RE: Geotechnical Report Addendum #1  
Proposed Muti-Unit Memory Care Development  
235 Dunn Street; McMinnville, Oregon

This document is intended to provide responses to the requested items that were recently issued to you by the City of McMinnville 3<sup>rd</sup> Party Geotechnical Engineer (GRI<sup>1</sup>). Our response to the numbered items is as follows:

APPENDIX A.1: STATIC & DYNAMIC ANALYSIS OF SLOPE  
NON FLOOD CONDITION

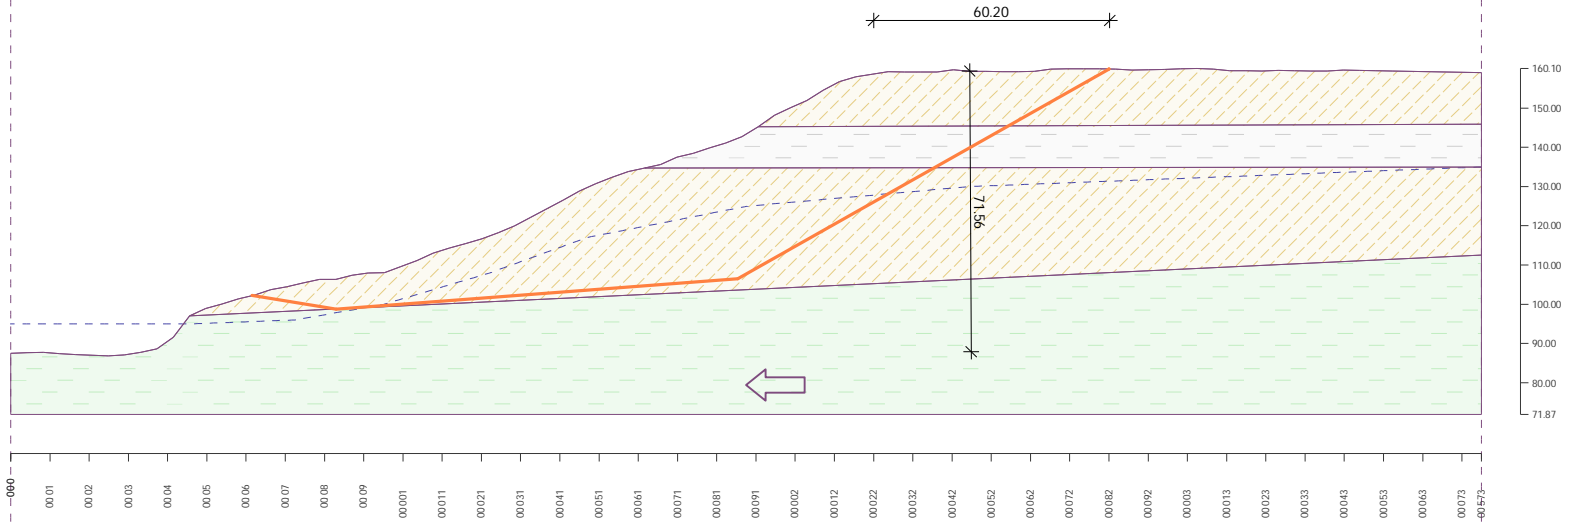
**Item 2** - Geological/geotechnical hazards should be evaluated using current 2022 OSSC including review of dynamic slope stability. Sufficient factor of safety at the proposed building offset from the crest of the slope should be demonstrated.

Response: Included with this Addendum #1, STRATA completed an updated analysis of dynamic slope stability. We deem that the dynamic factor of safety achieved demonstrates that the slope setback criteria of 60-feet remains valid. The dynamic analysis included accounting for the conditions of pseudo-static (seismic), and the 100-year flood elevation level. The full analysis report is attached (Appendix A).

## APPENDIX A.2 : SLOPE STABILITY ANALYSIS - WITH FLOOD CONDITION

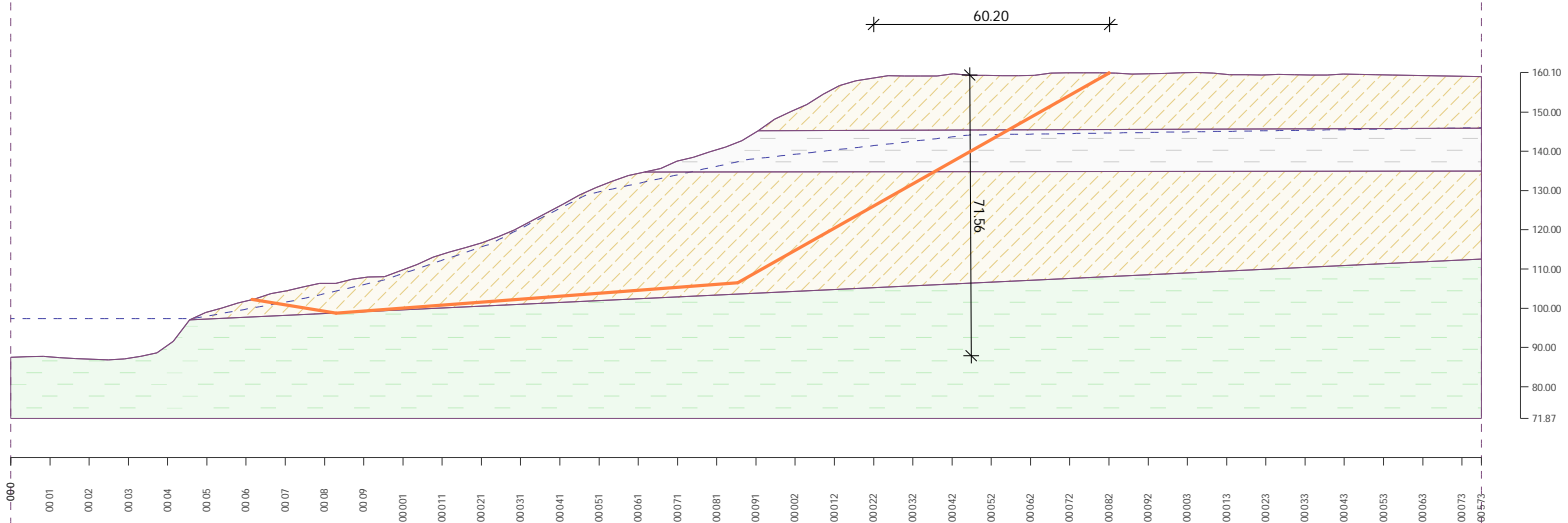
**Item 3** - Slope stability analysis should confirm adequate factor of safety is achieved during an appropriate flood stage. Selected flood elevation should be clearly identified and referenced.

Response: Included with this Addendum #1, the updated analysis of dynamic slope stability factored in flood elevations based on a 100-year elevation of 120 feet (NAD 88). The 1996 recorded flood level was about 110-feet (NAD 88). The top of the river bank is around Elevation 160 feet (NAD 88).
